**LEGAL ADVERTISEMENT
HISTORIC PRESERVATION BOARD
CITY OF PORTLAND**

**PUBLIC HEARING
59 CHADWICK STREET**

TO: Chair Sheridan and Members of the Historic Preservation Board
FROM: Rob Wiener, Preservation Compliance Coordinator
DATE: September 14, 2018
RE: September 19, 2018 **PUBLIC HEARING**

Application for: Certificate of Appropriateness for Window Replacement
Address: 59 Chadwick Street
Applicant: Patty and Ed Howells
Project Architect: Joe Delaney, Whipple Callender Architects

1
A1.2 EXISTING WINDOW DETAIL

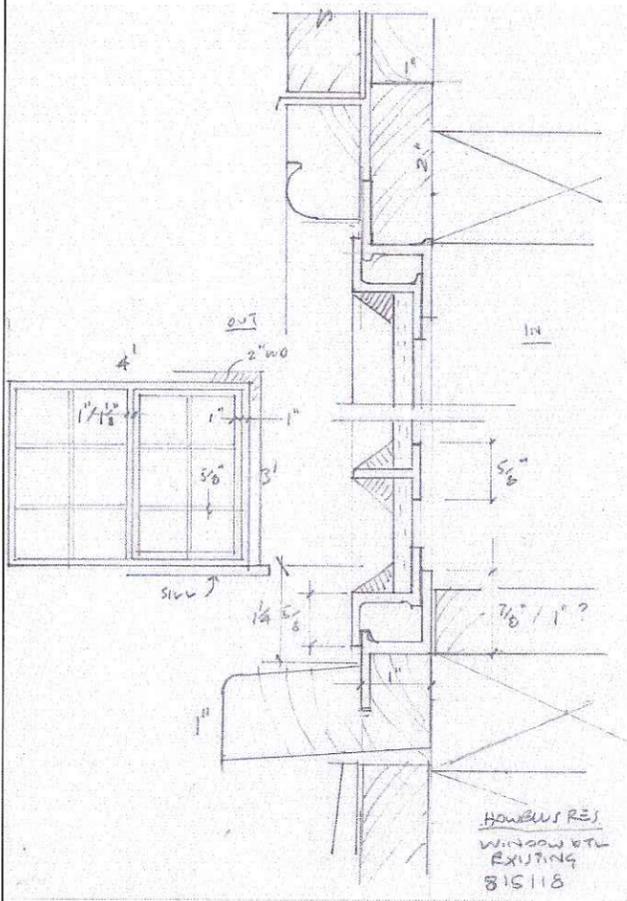
Staff notes that the relationship of the windows to the walls differs on different floors, because the first floor windows are set back in the masonry openings, while the second floor windows are closer to the face of the wood framed walls. Also, the casing on the second floor windows gives them a different appearance. In some rooms windows that appear to be double casements are not - only one side opens, while the other is a fixed unit.

The Secretary of the Interior's Standards for Review of Alterations to Historic Buildings, particularly Standards 2, 5, and 6 (see Applicable Review Standards, below,) clearly favor repair over replacement of historic windows, when possible. The threshold question of whether replacement is warranted must be judged on a case-by-case basis, in consideration of circumstances such as existing conditions, the potential for repairs, the significance of the property, the importance of the character defining features in question, and the authenticity and visual accuracy of any proposed replacement materials. Some questions associated with repair include:

- How serious is the damage? Can windows be repaired in place, or must they be removed to properly repair? Could all windows be fully refurbished?
- If repair off-site is called for, how difficult or potentially damaging would removal and replacement be to the windows and the house?
- To what extent is it appropriate to weigh the cost and end results of a repair program against a program of replacement?
- Are any of the windows considered unrepairable without significant reconstruction?
- Any repair program would undoubtedly be accompanied by the addition of interior storm windows and screens.

1 | SOUTH ELEVATION
1/8" = 1'-0"

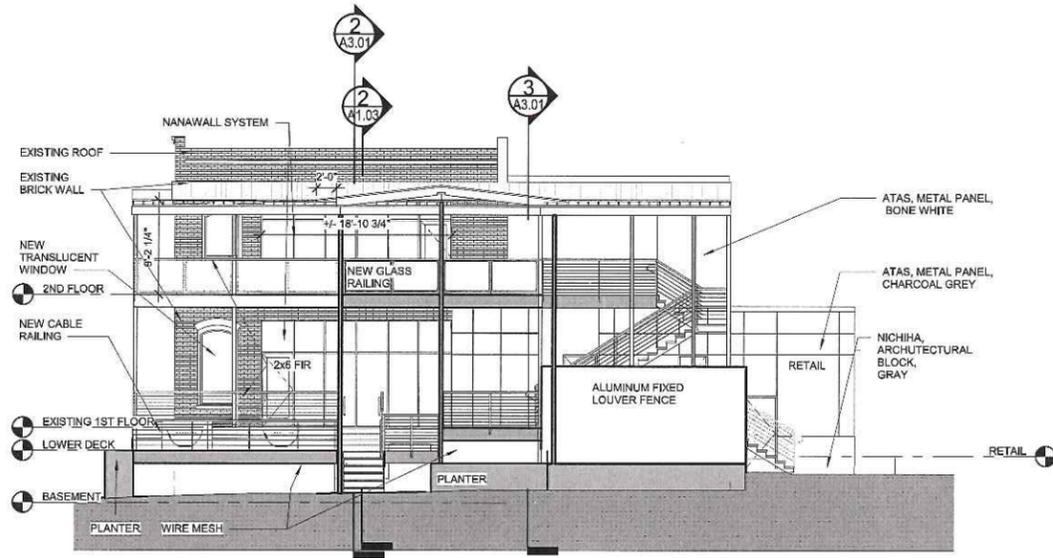
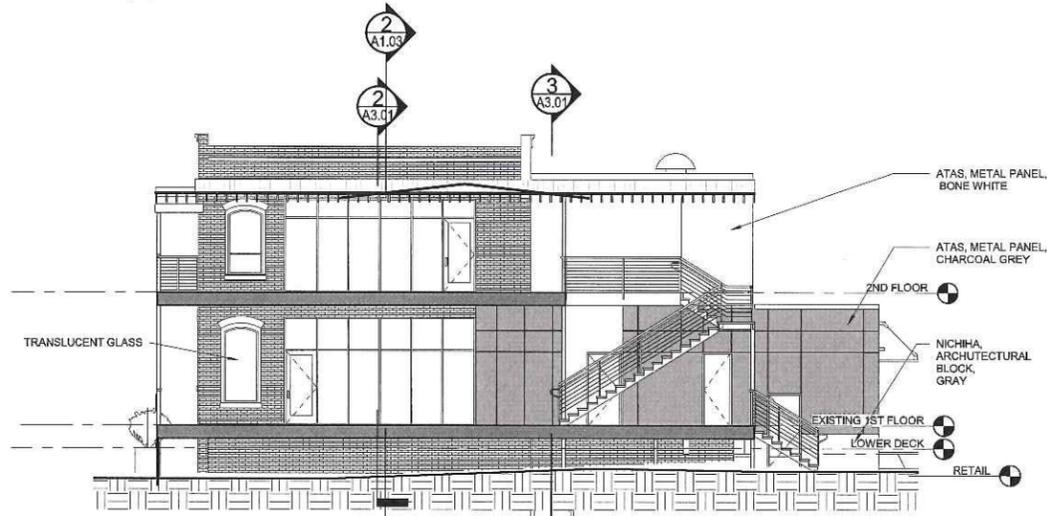
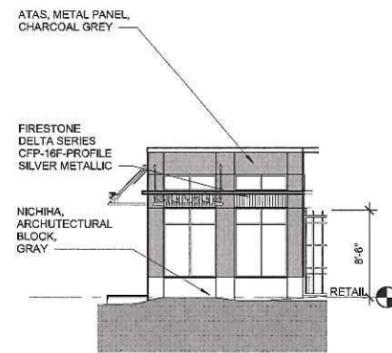
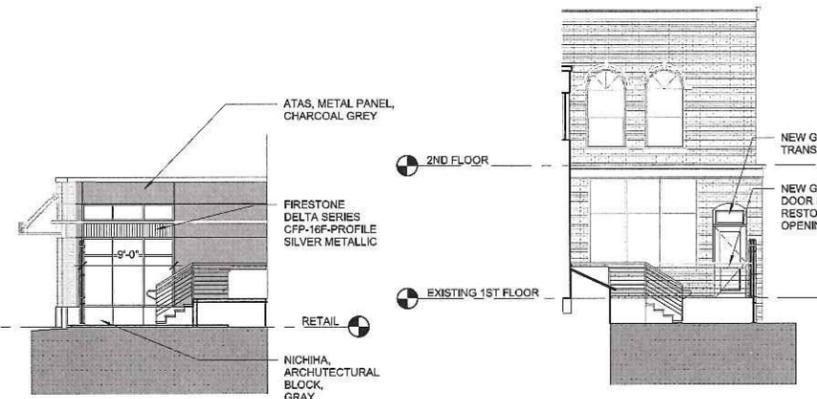
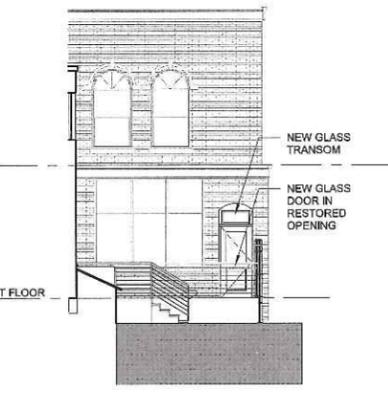
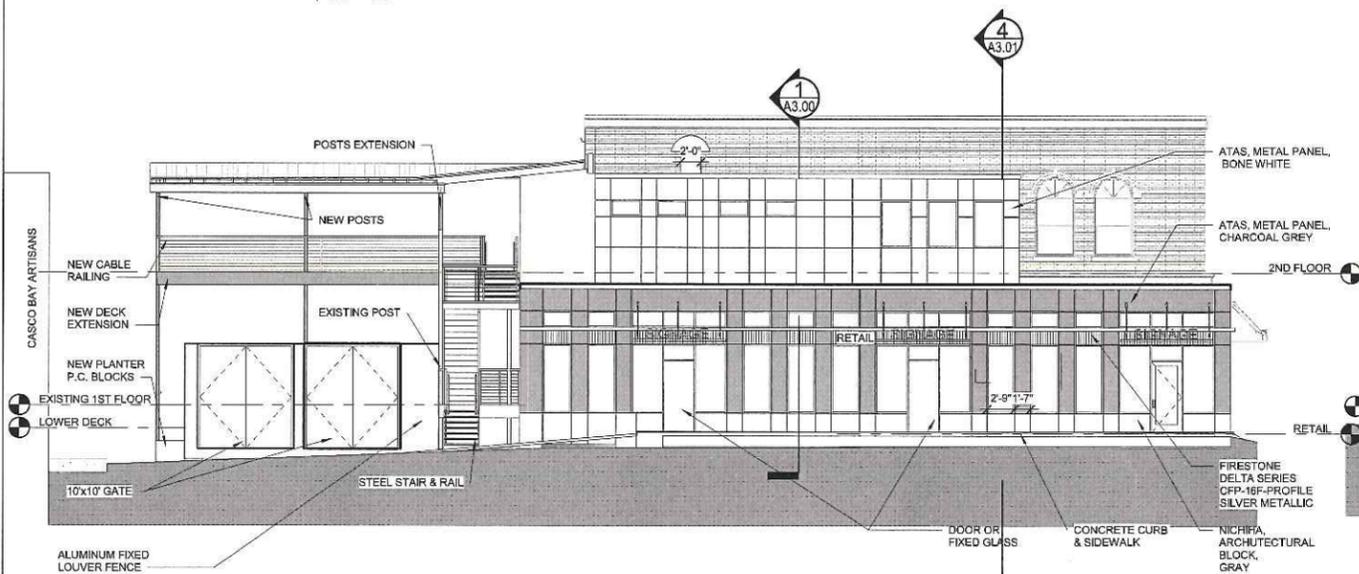
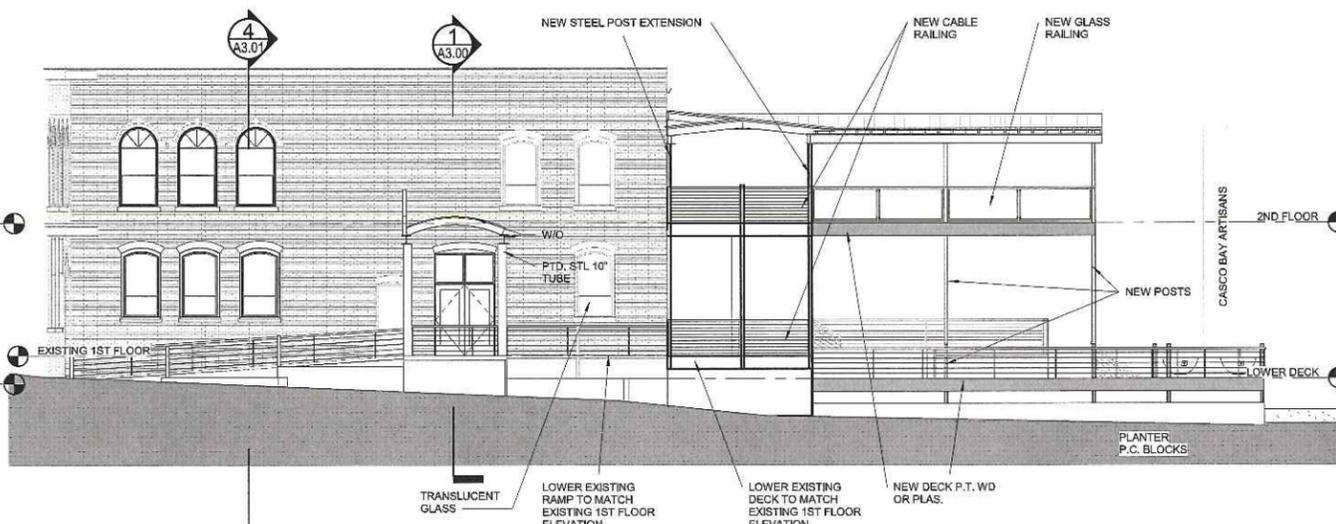
A question for consideration is whether the use of three distinct color palettes is desirable in this tightly spaced complex. Recognizing that the bone white chosen for the kitchen addition will likely relate to the existing building’s trim color, is the high level of tonal contrast with the existing structure desirable?

- The courtyard between the existing structure and the retail building has been modified considerably since the first design proposal. The front façade of the kitchen addition has now been moved forward, eliminating the space that separated the rear of the existing building’s projecting bay and the new addition. The planter has been removed and a gate and short retaining wall have been introduced at the sidewalk edge. From the applicant’s narrative, it appears that the side door on the existing building’s projecting bay will provide egress for the restaurant.

- The revised proposal includes a “pergola-like” feature with signage to mark the new entrance off the west elevation. Additionally, bars have been added to the steps of the original entrance to prevent passage.

Following up on concerns expressed by the Board at the first workshop, staff questions the decision to abandon the original front entrance, which is a key architectural feature

and focal point of the façade. Not only does relocating the entry disregard the original architectural intent of the building, it requires the introduction of additional elements to flag its new location and prevent access at the original entry. In staff's view, these types of added elements in an already complicated, multi-component building complex begin to tip the balance as to how much reworking of an original structure is acceptable within the ordinance standards.

- On the rear elevation, staff questions the desirability of extending the second-floor canopy out to the western edge of the deck. (The deck itself extends beyond the edge of the building.) In staff's view, the edge of the canopy should be held back from the corner, allowing the corner to be kept clear of additional projecting elements.
- Staff questions the rationale for using both glass railings and cable railings for the deck.
- A perspective view from Maine Wharf looking toward the rear of the building complex would be helpful.

1. The courtyard has been pulled closer to Commercial Street. Planter removed. Gate added. Exit from restaurant moved towards street in a restored opening.
2. 2 Story addition has been lowered to align with existing 2nd story windows on east side of Drydock. Modification of window placement.
3. The retail addition has been further developed.
4. The utility pen has been further developed. See attached louver photo
5. The rear wall facing Casco Bay has been modified with the existing window openings retained at the western end.
6. The roof above the exterior 2nd floor decks has been detailed. See attached photo of plastic
7. The main entrance on the west wall has been further detailed.
8. The former entrance on Commercial Street has been further detail

1 | BACK ELEVATION
1/8" = 1'-0"

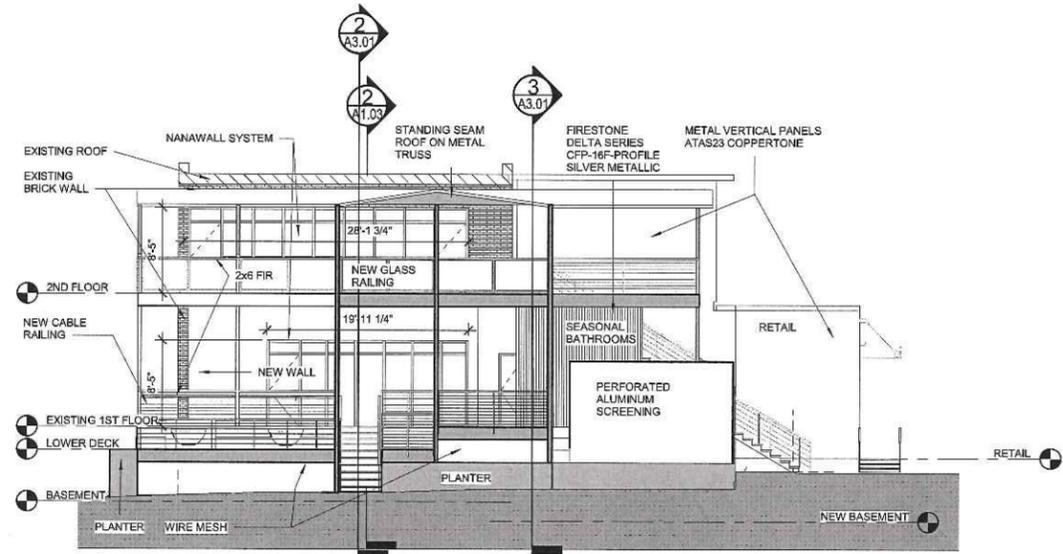
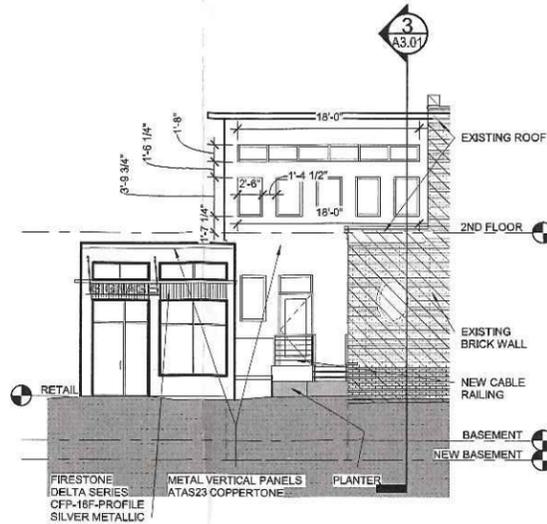
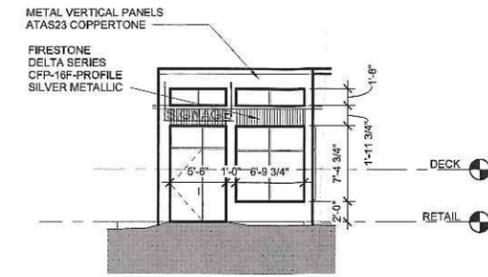
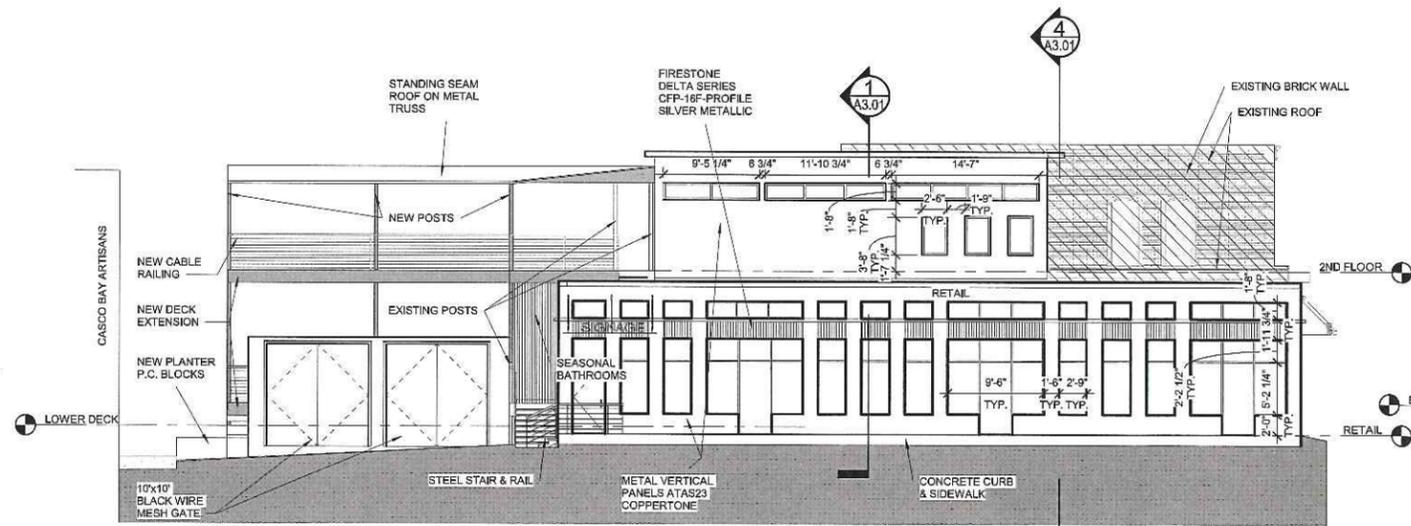
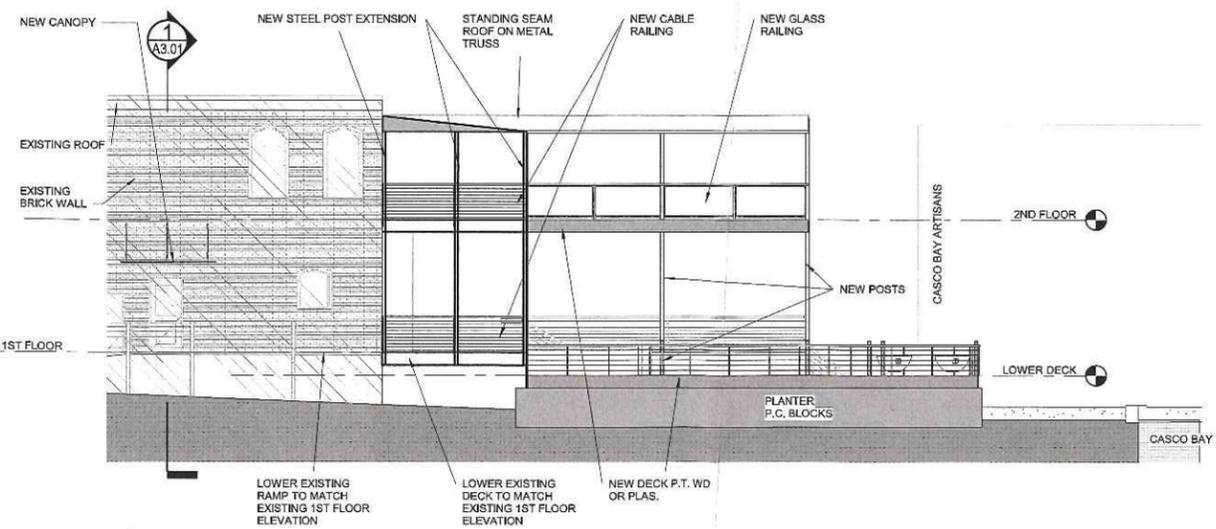
- Exterior materials and finishes. Questions were raised about the materials under consideration for the two additions. If a panelized exterior material was being proposed, what size panels were being considered? The project architects indicated that exterior materials had not yet been finalized and that they were seeking input on this question. While various materials were discussed, no specific material recommendations were made. From staff notes, there appeared to be some discussion as to the advisability of using the same material/color palette for both new additions.

- Courtyard between existing single-story bay and retail addition. Questions were raised about the proposed function and treatment of this area. What was the purpose of the raised planter? Would the ATM be retained? Would the existing door opening (where the ATM had been installed) be used for egress?

- Restaurant entrance. Board members expressed concern about the ramifications of moving the main entrance of the restaurant to a doorway on the west elevation which is accessed by an existing ramp. In conjunction with this change, the submitted plans suggested that the existing recessed main entrance would be infilled. Board members did not support infilling the existing entrance and encouraged consideration of an interior program that did not render the original entrance obsolete. (see ordinance Standard #1). Board members also indicated that if the main entrance were moved, visual cues would need to be provided to direct patrons to the intended entrance.

- Rear elevation, removal of section of brick wall. Responding to the plans that showed most of the rear brick wall--particularly at the second-floor level--being removed, Board members suggested that the westernmost bay of the rear wall be retained as is to provide a more solid corner for this elevation.

- Rear decks. One Board member noted that the rendering of the rear decks and canopies was likely misleading, as it depicted the decks and canopies as having a very light visual appearance. In reality, the decks and canopy will likely need to be heavier to provide the necessary structural support, etc. The project architects were encouraged to provide more accurate renderings with the second submission. The consultants were also asked to consider what exterior lighting would be proposed for the rear decks.

- Dumpster area. Questions were raised about the visibility of this area and what screening would be provided.
- Additional information requested. Board members recommended that the roof heights of the existing structure and additions be modeled so that the relationships could be better understood. A rendering of the rear of the complex as viewed from Maine Wharf would also be helpful.

1 | SITE PLAN
1/16" = 1'-0"

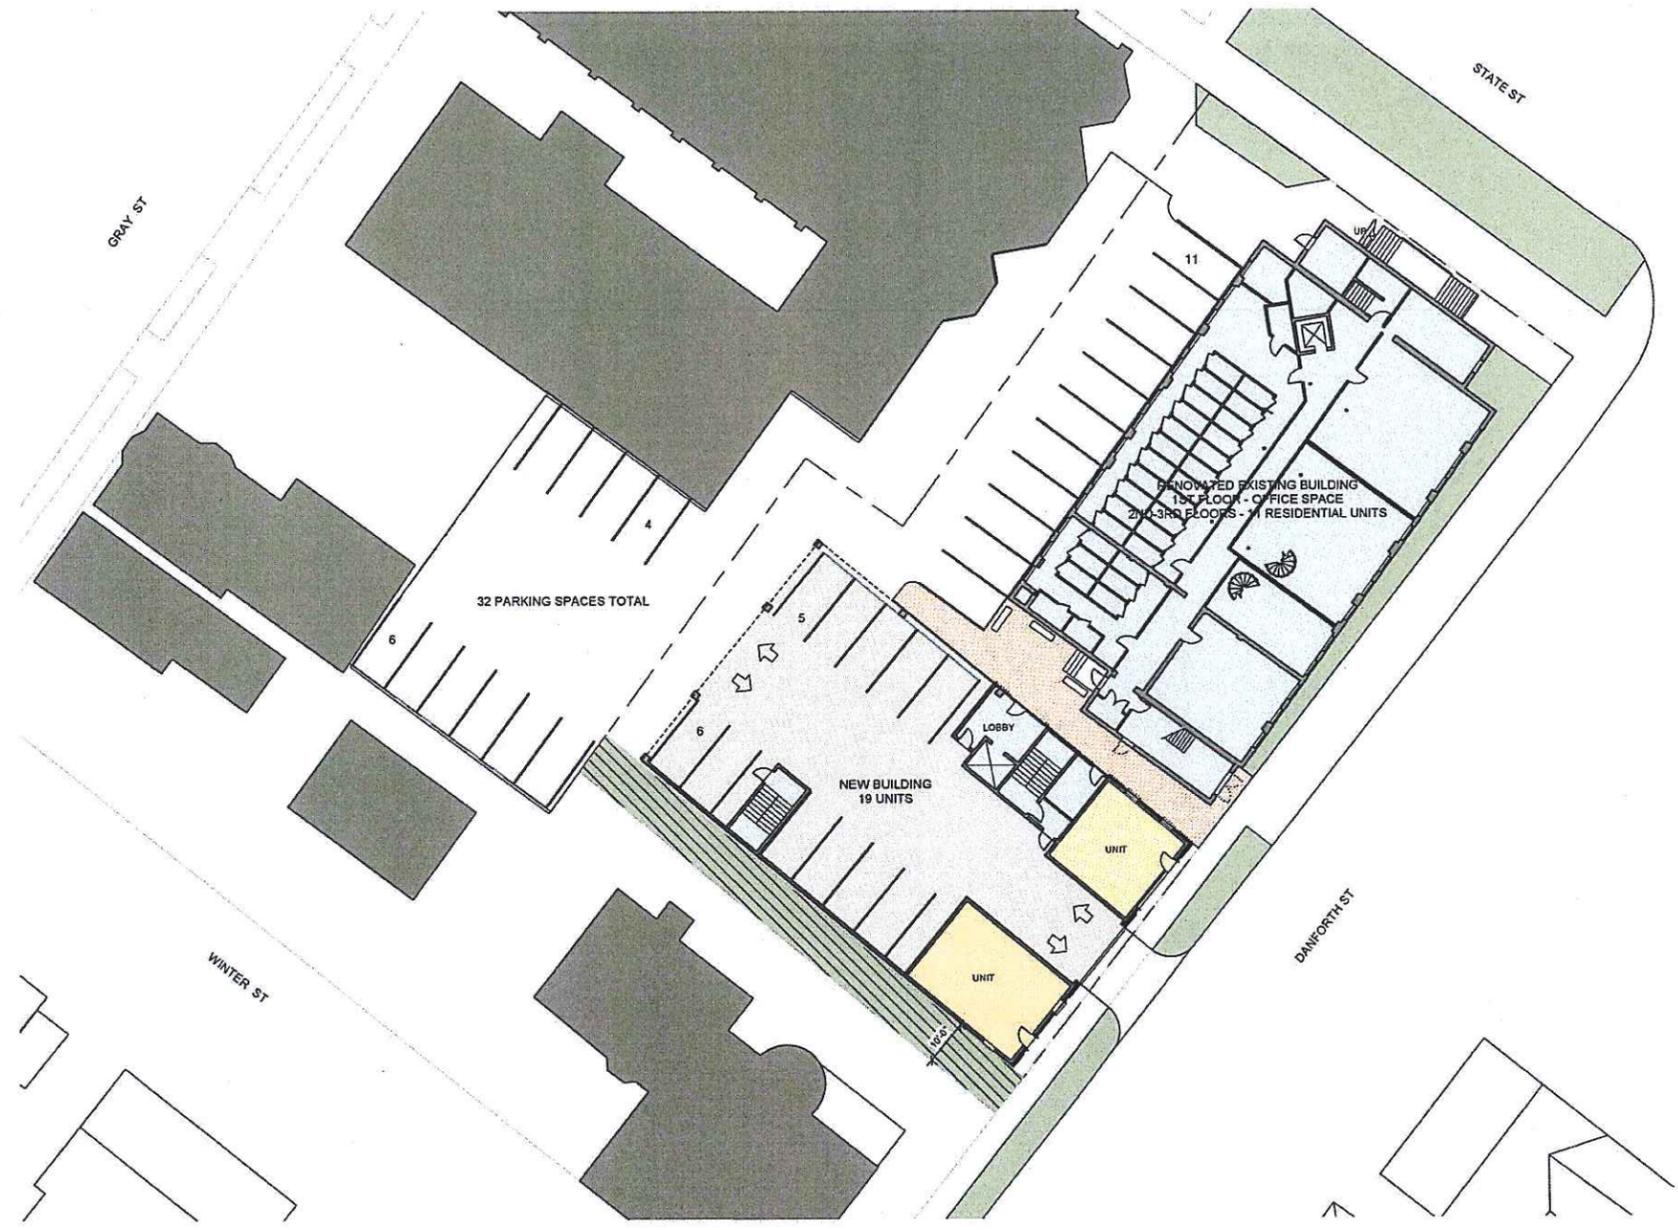
The proposed design responds to a number of building characteristics exhibited in the surrounding context (symmetrical façade composition, vertically-proportioned upper floor windows, etc.) and aligns with some key datum lines of its immediate abutments. A threshold question for consideration, however, is whether it is appropriate that the main entrance of the new building be located on a side elevation well away from the street and the center of the ground floor façade be dominated by a garage door. In an area distinguished by high style buildings with formal facades, most of the building entries are the most dominant architectural feature of the façade. The proposal to replace the entry with a garage door seems unfortunate in this context. The Board may wish to explore with Mr. Lloyd and the applicant whether the garage entrance could be positioned on the east side elevation, accessed from a wider driveway separating the school building and the new structure. This might necessitate a narrower structure as viewed from Danforth, but perhaps the rhythm of spacing between structures would be improved. Regarding access, the applicant should be asked to address all of the potential options for access to the site, including access from State Street.
